Addendum No. 1 December 3, 2025

City Project No. 23-068 Package 2 Roads Program Capital Improvement Project

This addendum includes revisions to Plans and Specifications and provides clarifications and answers to questions submitted to the City.

(F) denotes final pay item per Section 9-1.02C of the State Standard Specifications.

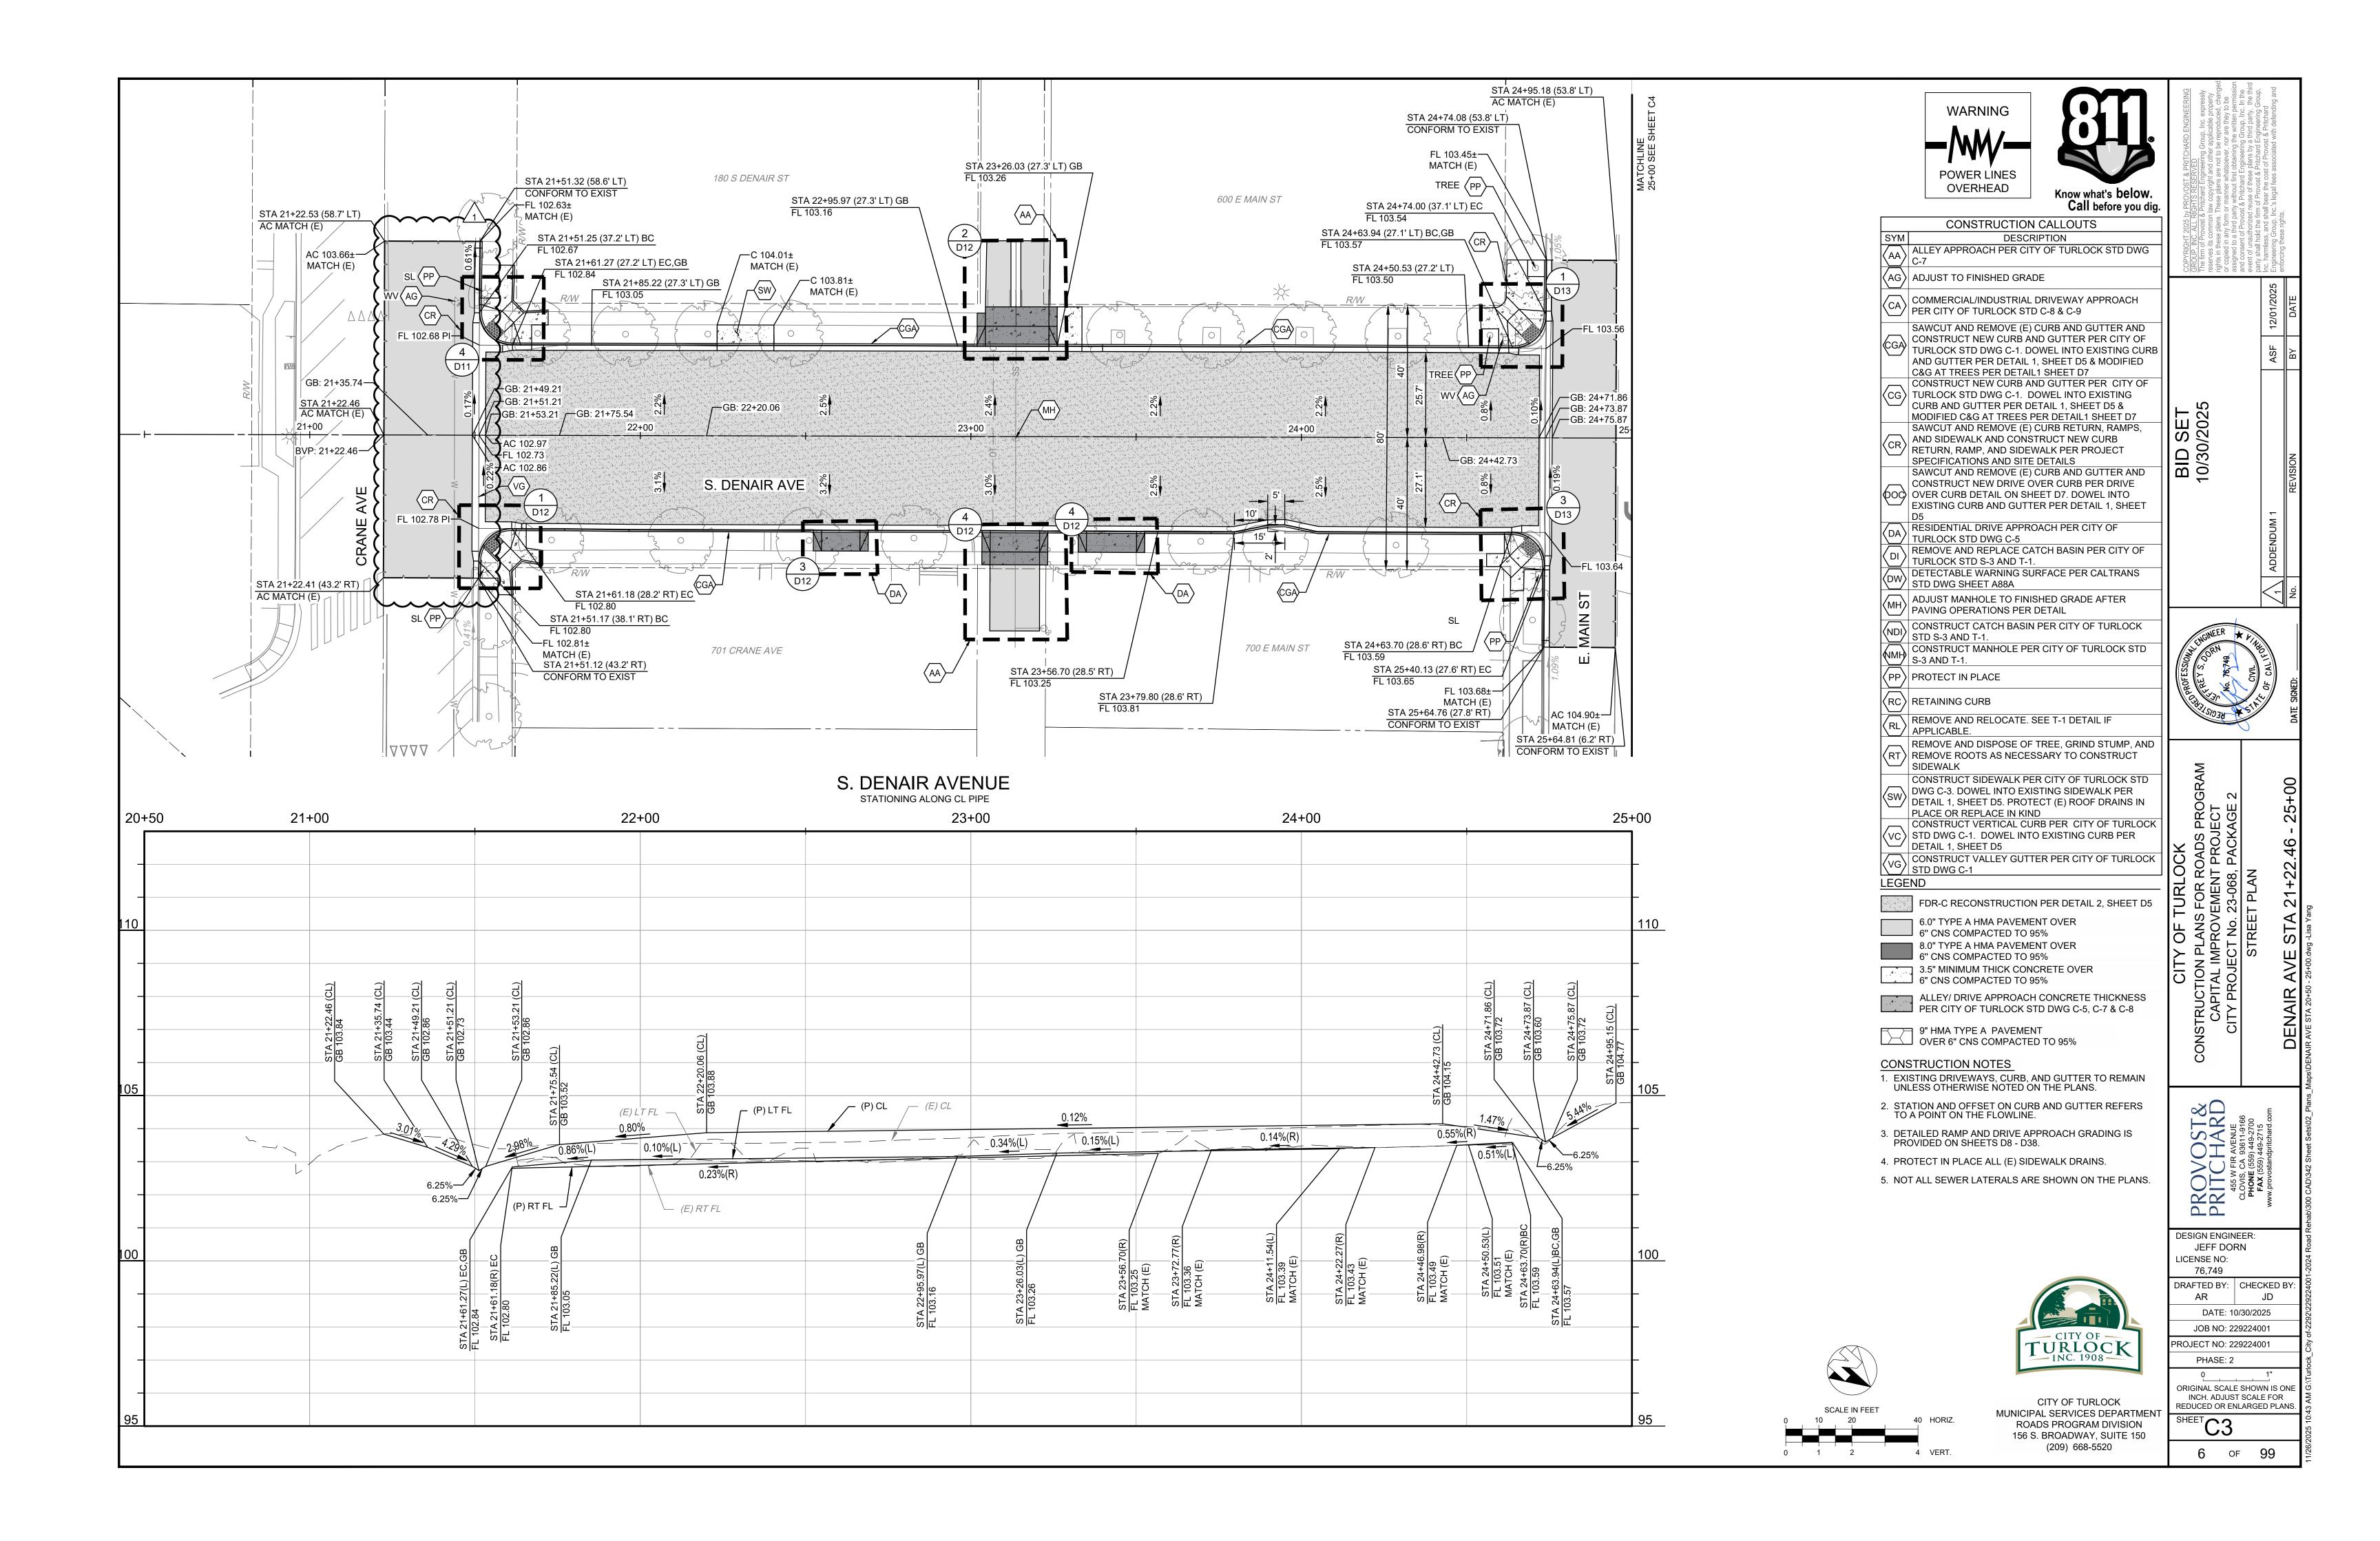
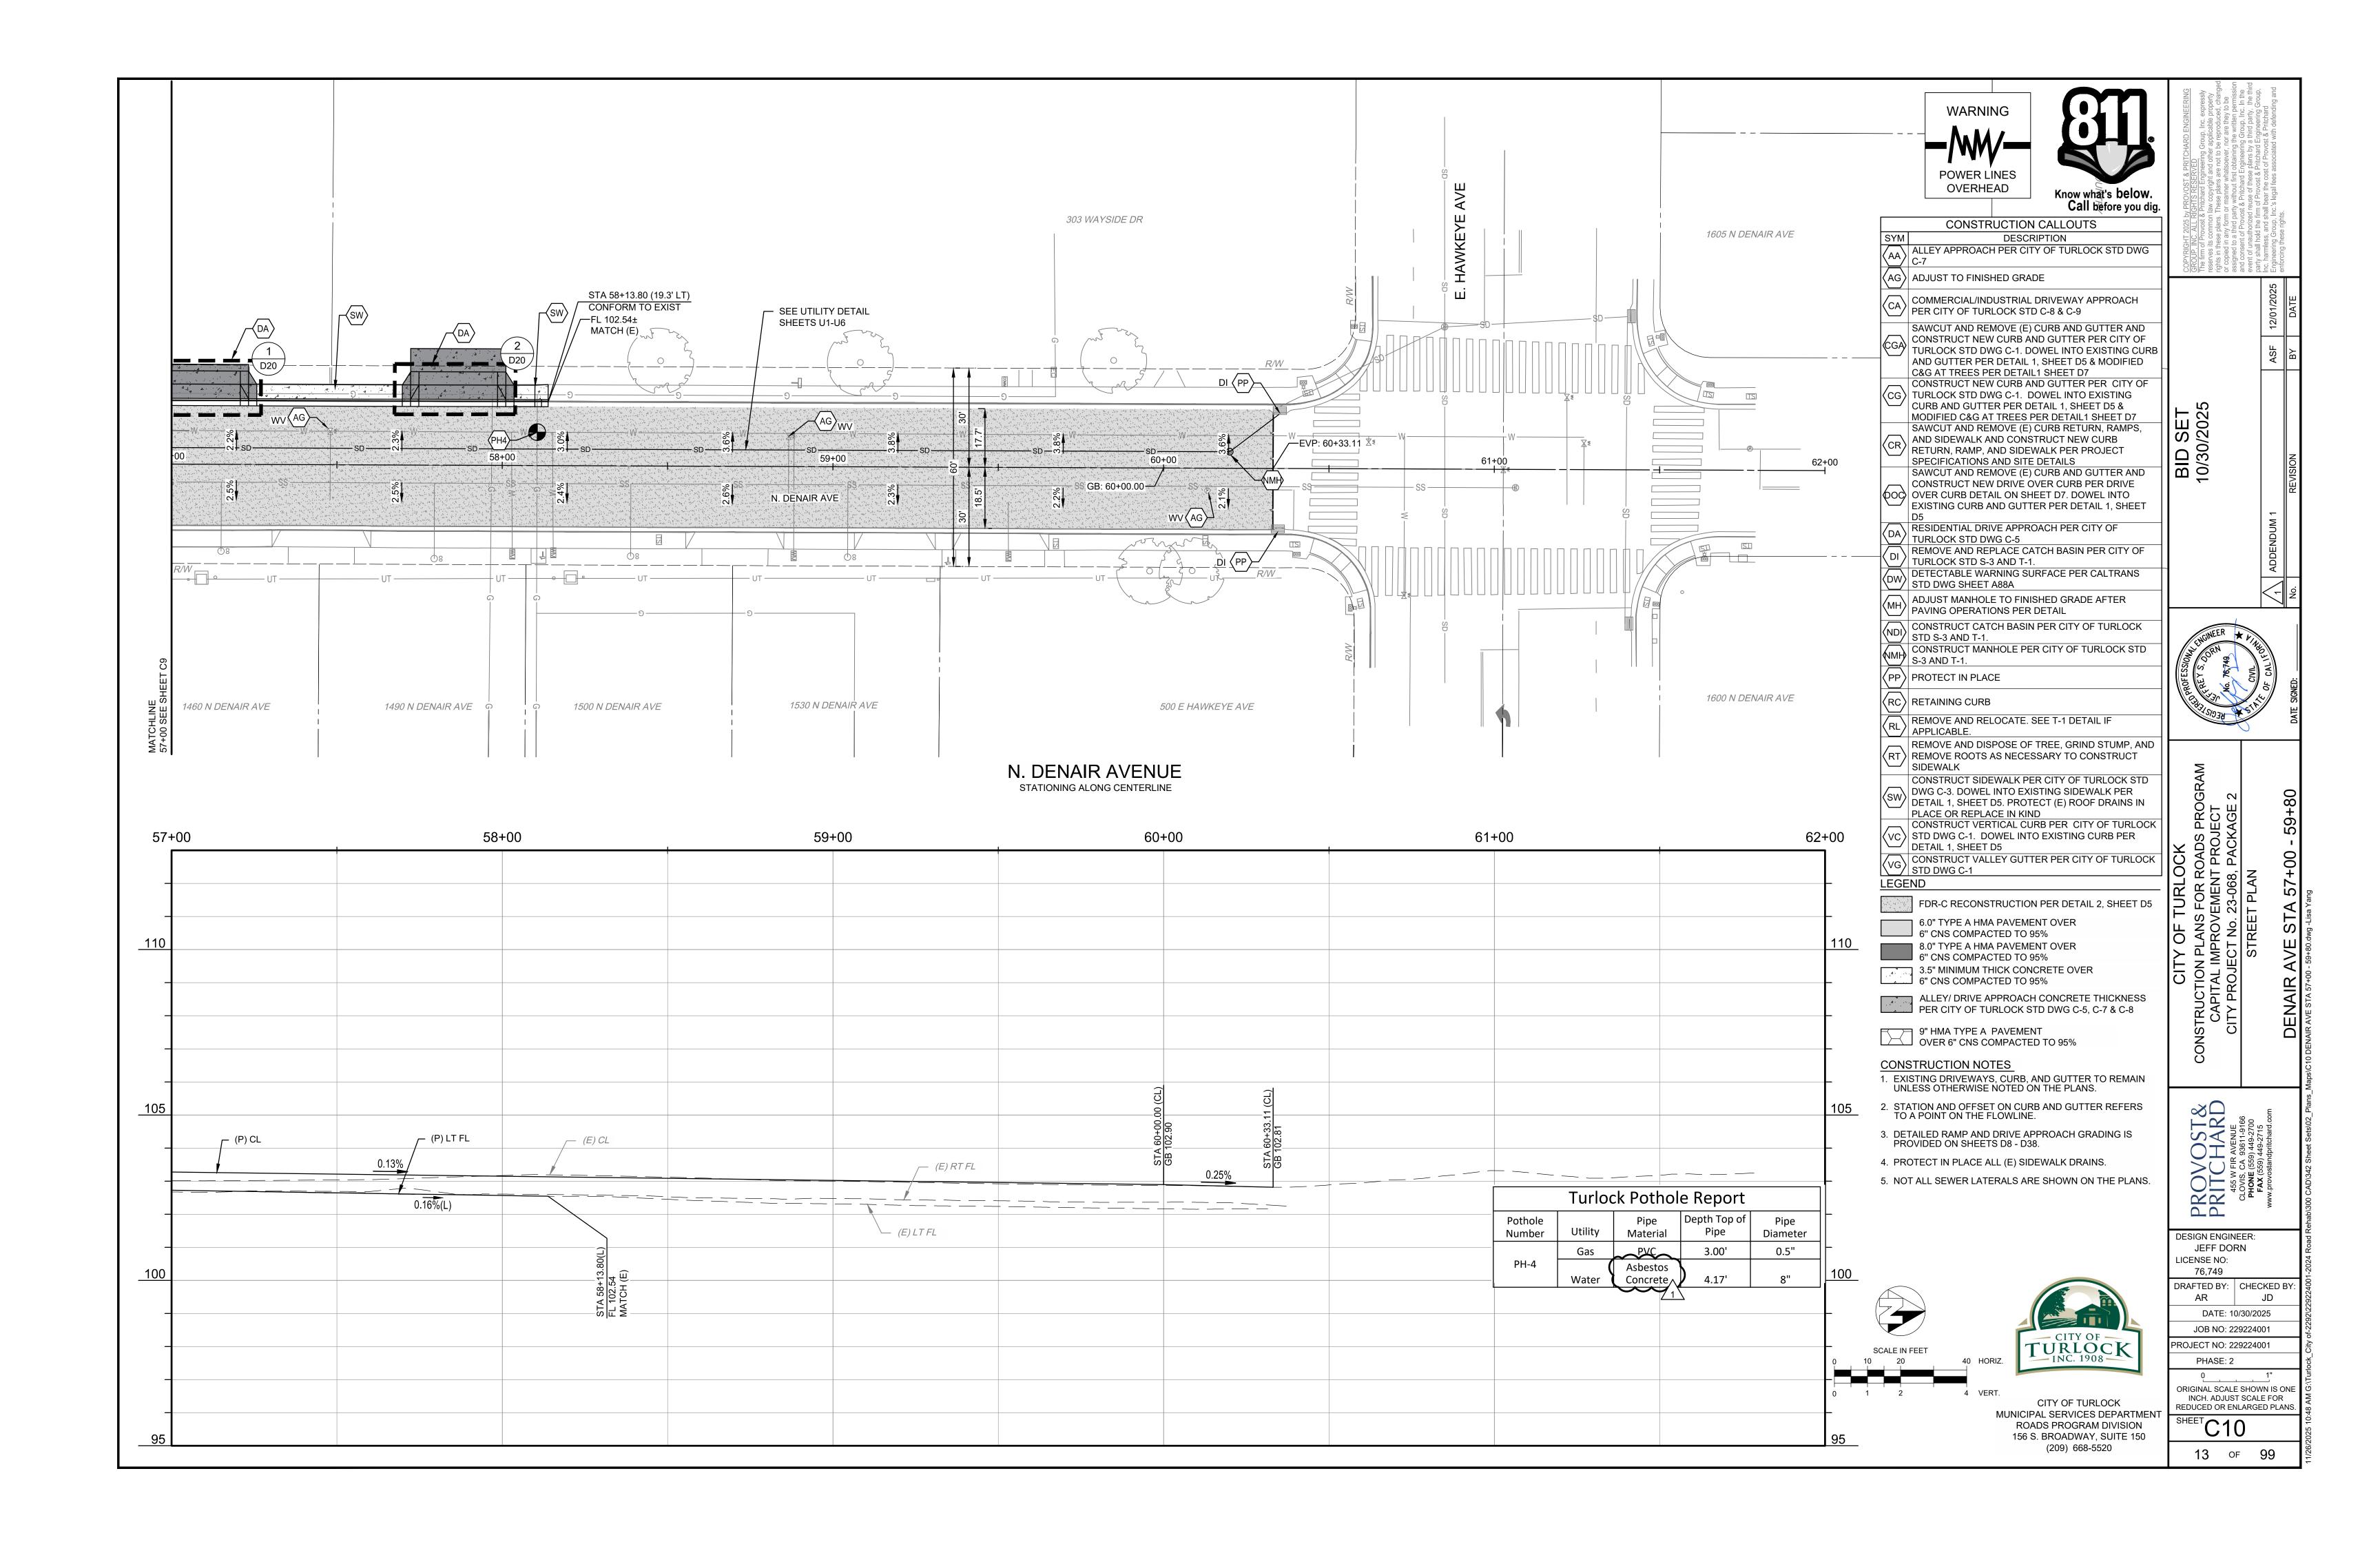
Delete sheets C1-C3 and replace with attached sheets C1-C3 of this addendum. Revisions consist of changing the street rehabilitation method and pothole report table.
